## Certificate of Appropriateness

*Filing Date:* August 16, 2024  
*Case Number:* **24-26-HPC**  
*Request:* **Certificate of Appropriateness**  
*Project Address:* 906 Wilkinson Street, Shreveport, LA 71104  
*Historic District:* Fairfield Historic District  
*Zoning:* R-HU (Highland Urban Conservation Residential District)  
*Applicant:* Matt Smith, Property Owner  
*MPC Review by:* Peiyao Li, Community Planning I  
Peiyao.li@shreveportla.gov  
*HPC Meeting Date:* August 20, 2024

906 Wilkinson Street is the site of the two-story residential structure located within the Fairfield Historic District. The applicant is seeking approval to replace terra cotta roof tiles with standing seam metal roof. With regard to the color of the roof, the applicant would like to use either a traditional muted terra cotta red that matches the traditional roof color of Mediterranean Revival architecture, similar in color to the roof on the Kings Highway Christian Church at 806 Kings Highway, or a green color like the roof at 1030 Kings Highway, or the roof at 2745 Fairfield Ave.

Exhibit D. Current Roof Images

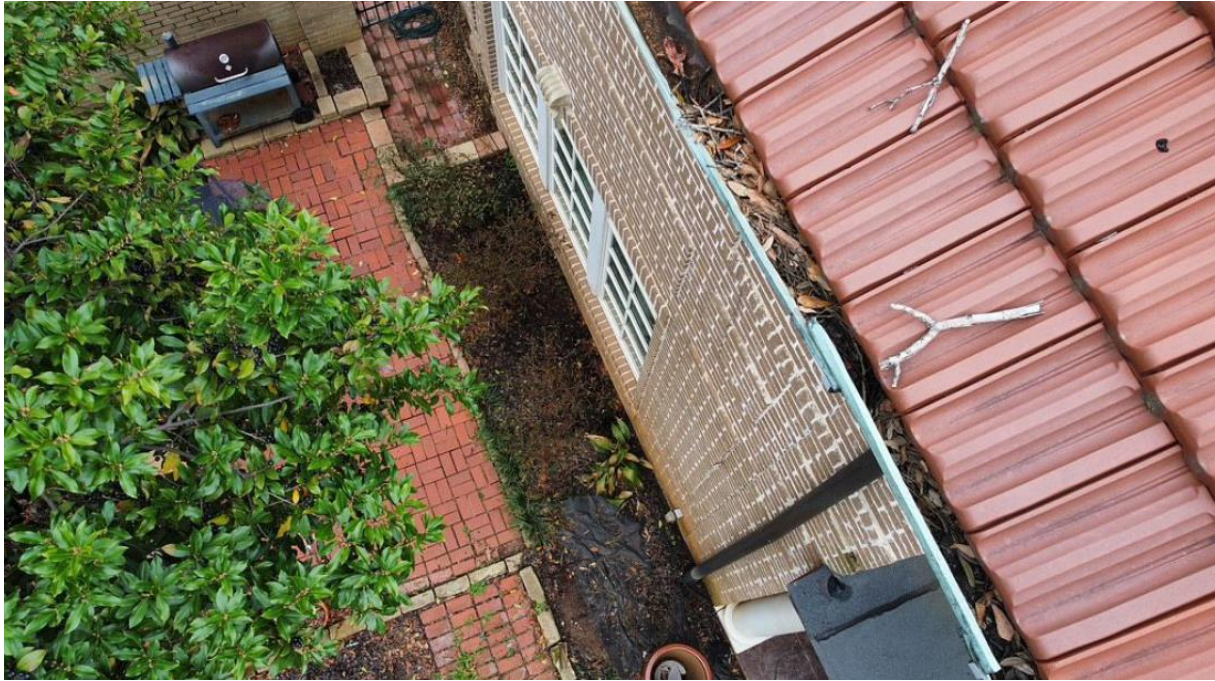
The proposed project would introduce standing seam metal roof that is mismatched for the roof of an Italian Renaissance Revival home. Italian Renaissance Revivalist roof featuring standing seam metal roof instead of a historically appropriate tiled roof would visually conflict with this site's historic significance as well as the overall integrity of the historic district of which it is a member.

**MPC STAFF COMMENTS: MPC staff finds that the architectural features of the proposed activities WOULD NOT be considered harmonious within the special character of the HPOD, as a standing seam metal roof is mismatched for the roof of an Italian Renaissance Revival home.**

**MPC STAFF COMMENTS: MPC staff finds that the proposed activity WILL adversely affect the exterior or architectural feature(s) and essence of the structure.**

**MPC STAFF COMMENTS: MPC staff finds that the proposed activity WILL adversely affect the historic character of the structure and area, as metal is not historic or typical roofing material.**

MPC staff recommends DENIAL of the requested Certificate of Appropriateness, with the suggestion of the following alternatives:

1. All efforts should be made to ensure that the authenticity of the home's original & historic style is retained. Roof materials to be replaced shall not diverge from the historic and authentic style of an Italian Renaissance Revival home.
2. Synthetic, non-clay roof tiles matching the historic Italian Renaissance Revival style requirement can be sourced from a variety of manufacturers (at reduced cost) and can be used in lieu of imported clay tiles.
